1992 Mercedes Benz 600SEL (140 Chassis) V12-5987cc 6.0L DOHC (120)

Sunroof - Retrofitting Steel with Glass

Date: July 1992

RETROFIT OF GLASS SLIDING/POP-UP ROOF PANEL

Figure 1

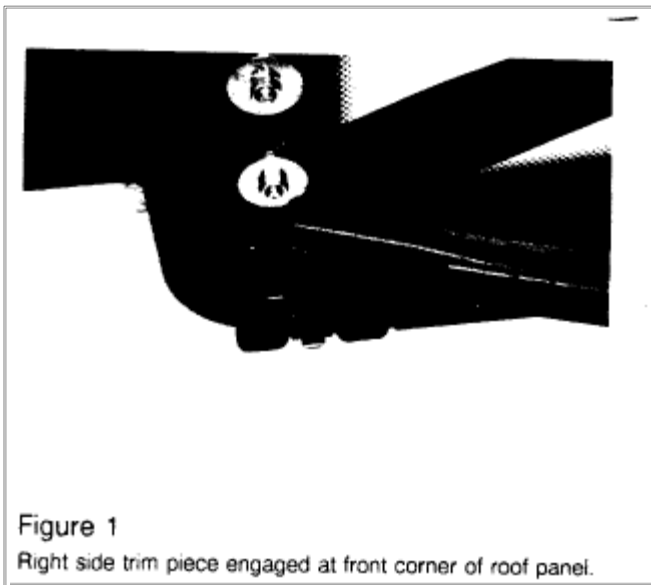
7. Install new side trim ("bellows") pieces. Engage trim piece at front of roof panel onto tilt bracket assembly as shown in Figure 1.

Figure 2

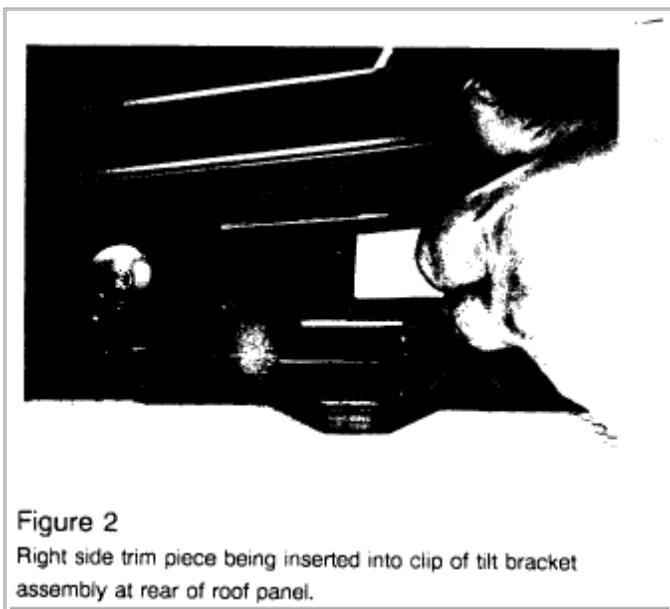
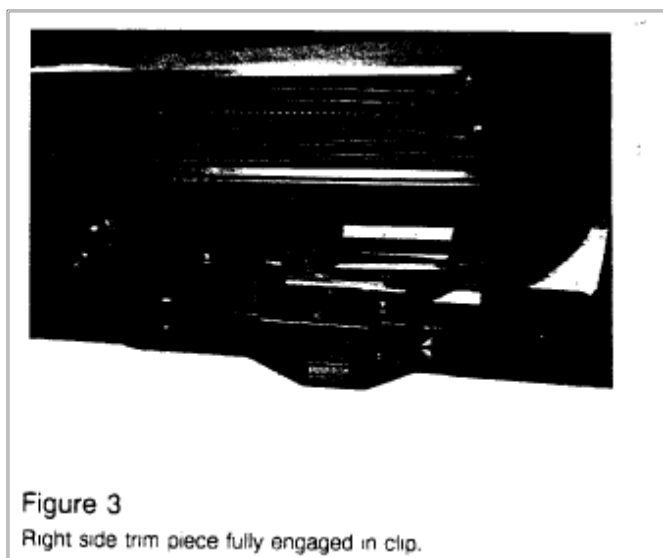
8. Slide rear of trim piece into clip on tilt bracket assembly until fully engaged (Figures 2 - 3).

Figure 4

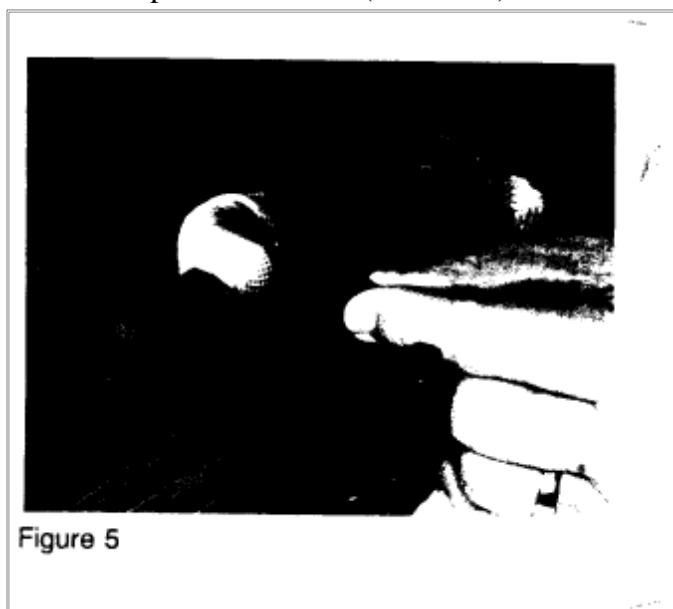
9. Insert top of rubber trim ("bellows") into channel in roof panel (Figure 4).

Figure 5

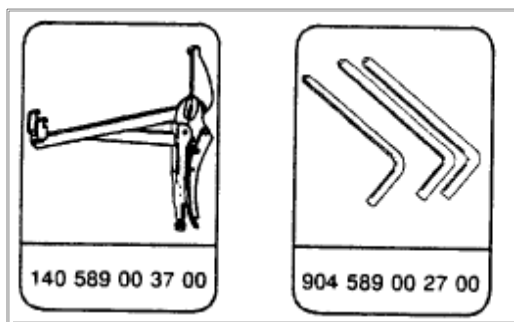
10. Insert tab at rear of trim piece into the hole provided for it at the rear corner of the roof panel (Figure 5).
